GEORGIA POWER COMPANY
OGLETHORPE POWER CORPORATION
MUNICIPAL ELECTRIC AUTHORITY OF GEORGIA
CITY OF DALTON, GEORGIA
VOGTLÉ ELECTRIC GENERATING PLANT, UNIT 1
AMENDMENT TO FACILITY OPERATING LICENSE

Amendment No. 92
License No. NPF-68

Amendment No. 70
License No. NPF-81

ATTACHMENT TO LICENSE AMENDMENT NO. 92

FIGURE 3.6-1

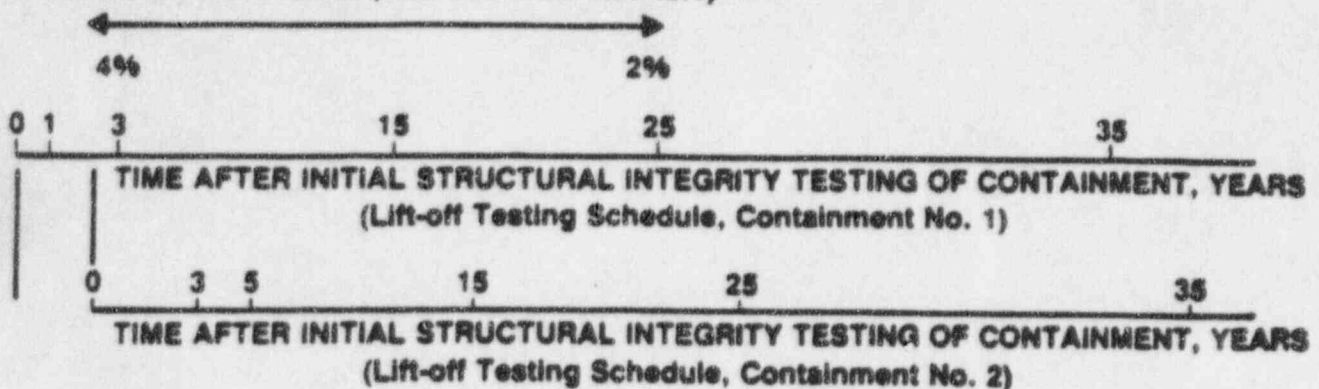
- a. The containments are identical in all aspects such as size, tendon system, design, materials of construction, and method of construction. The tendon system for Unit 2 does not provide for detensioning. Detensioning can be performed only on the Unit 1 tendon system.
- b. The 1-year inspection for Unit 2 will consist of a visual inspection only. No lift-off testing will be performed on Unit 2 until the 3-year inspection.
- c. There is no unique situation that may subject either containment to a different potential for structural or tendon deterioration.
- d. The Unit 1 and Unit 2 surveillances may be performed back-to-back to facilitate detensioning of Unit 1 tendons during the Unit 2 surveillance.
- e. In order to perform back-to-back surveillances on Units 1 and 2, the Unit 1 10-year surveillance and the Unit 2 5-year surveillance are to be performed between 5/1/95 and 11/1/95.
